ADDENDUM NO. 1

**GMIA – AIRFIELD ASPHALT PAVEMENT REPAIR & OVERLAY**

PROJECT NO. 5051-11001

OFFICIAL NOTICE NO. 6669

TAXIWAY SHOULDER HMA OVERLAY DETAIL

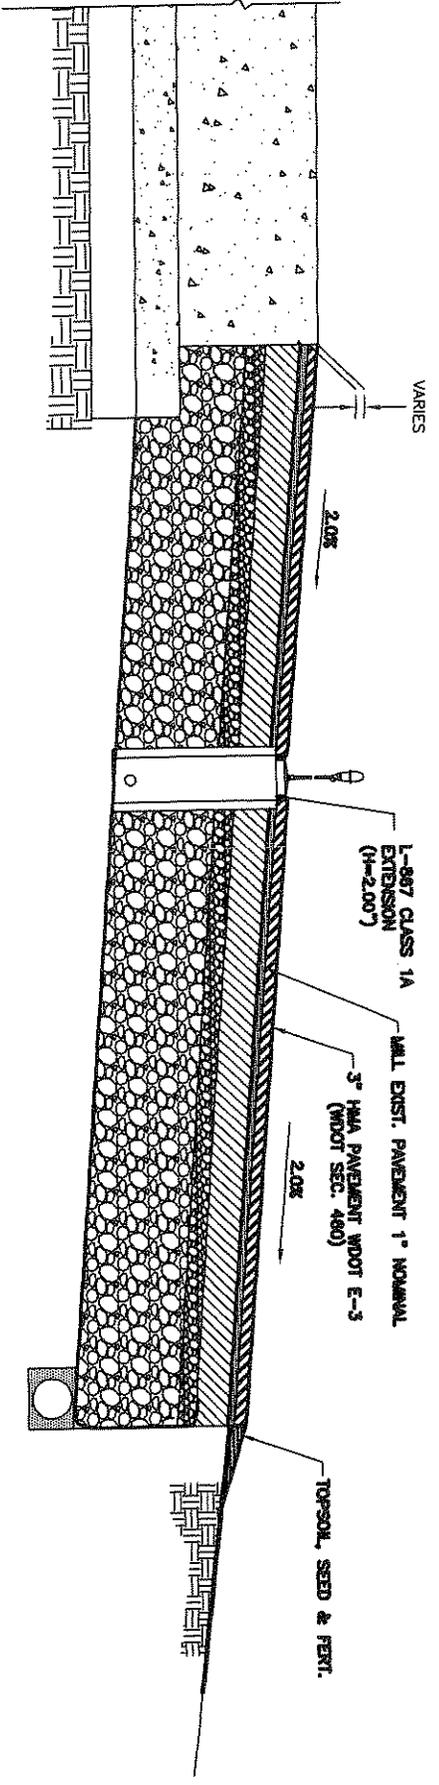
Sheet 7 of 7

Replace the Taxiway Shoulder HMA Overlay Detail with the attached drawing.
